WATER PERMIT NO. 1978-1

M 020-372, Ziebach County, PCN I4YV

Re: **M 020-372, Ziebach County, PCN I4YV**
SD20, 5 miles west of Jct. SD20/SD65 west of Isabel
Inslope Erosion Repair & Downspout Replacement

REPORT ON
WATER PERMIT APPLICATION No. 1978-1
South Dakota Department of Transportation
June 1, 2018

Permit No. 1978-1

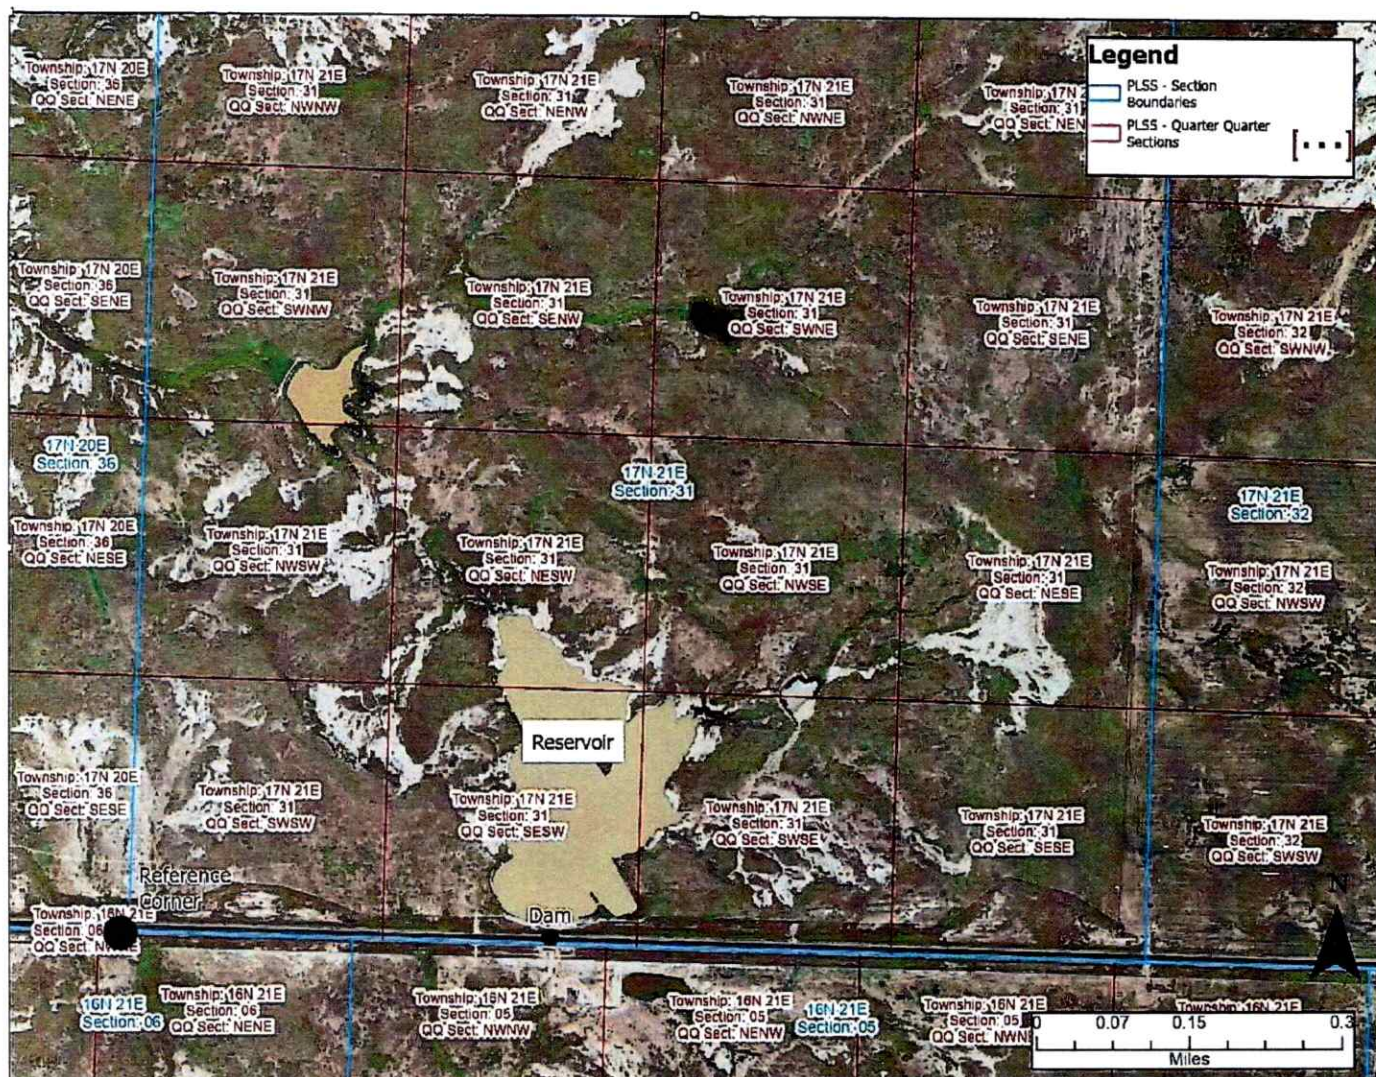
The primary spillway is a CMP lined with 24" plastic pipe that outlet into a riprapped earthen channel across the downstream berm to the downstream toe (see pictures). The fence around the riprap portion of the primary spillway was down at the time of inspection. The plans in the permit file indicate an overflow area in the right abutment area. This area was grass covered and free of obstruction.

1. **The sinkhole on the downstream slope should be repaired and the cause investigated and addressed.** The areas of erosion on the downstream slope should be repaired and stabilized to prevent further erosions. Livestock grazing on the embankment should be managed to maintain an adequate grass cover and limit erosion.
2. **The erosion of the upstream slope along the waterline should be repaired and riprap added to prevent further erosion.**
3. The cracking on the downstream slope should be monitored. If the cracking worsens or does not behave like a drying crack and self-heal with wetter conditions, the cracking should be repaired.
4. The repaired/modified primary spillway should be monitored to ensure it is performing as intended, especially during higher flows.
5. Any seepage should be monitored for changes in quantity or clarity.
